**ADDENDUM NUMBER FOUR
FOR
DEPARTMENT OF VETERAN AFFAIRS
CHARLESTON, SOUTH CAROLINA**

**INSTALL SUMMER BOILER AND INSTANT WATER HEATER
PROJECT NUMBER: 534-10-105
LAI PROJECT NUMBER: 10502**

DATE OF ISSUE: February 22, 2012

PARTIAL LARGE SCALE PLAN ON DRAWING S-4

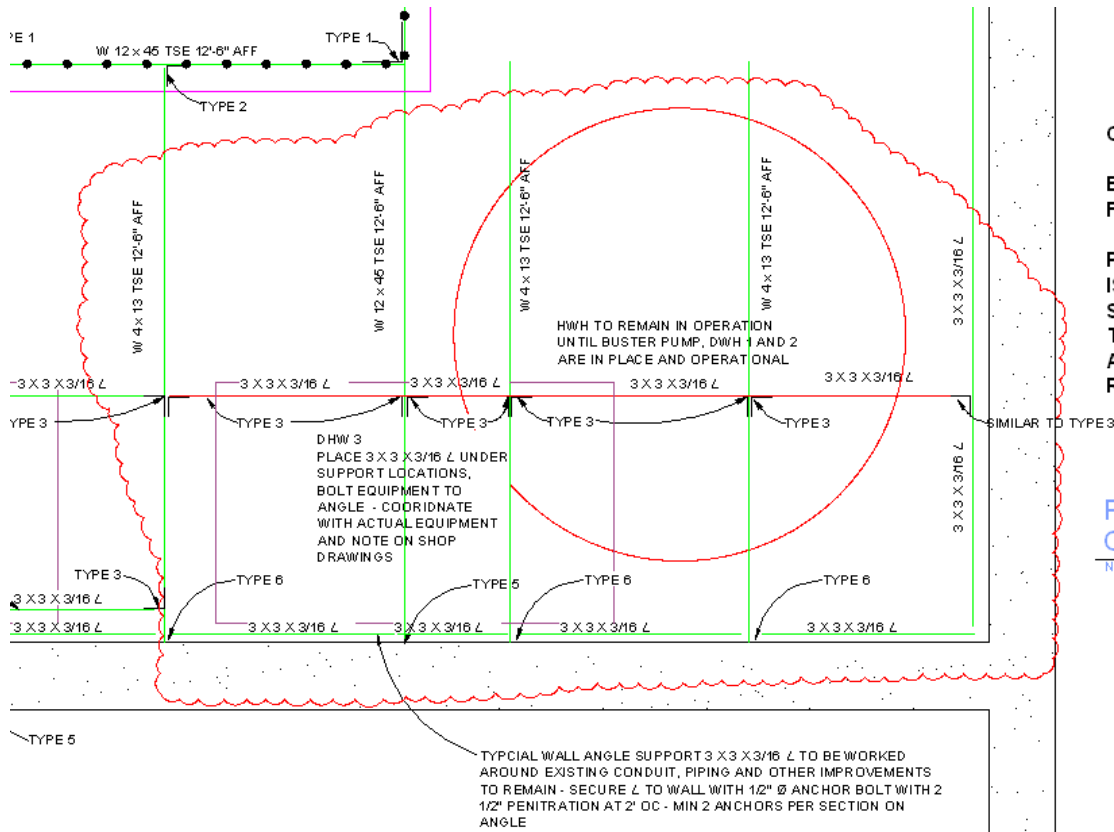
6. Drawing S-4 – **MODIFY** lower right portion of the Large Scale Phase 1 Plan to reflect the below:

Work shown in the below sketch is noted to support the DHW-3 to be installed after the removal of the existing HWH which is scheduled to occur in the second phase of the construction process. Modifications should also be added to 1/S-5. The support system shall be similar to that noted for the other two DHW Units 1 and 2.

PROVIDE SUPPORT FOR DHW 3 THAT IS SIMILAR TO OTHER DHW UNITS - SEE DRAWING P-2 FOR LOCATION - THIS WORK WILL BE ACCOMPLISHED AFTER THE EXISTING HWH IS REMOVED.
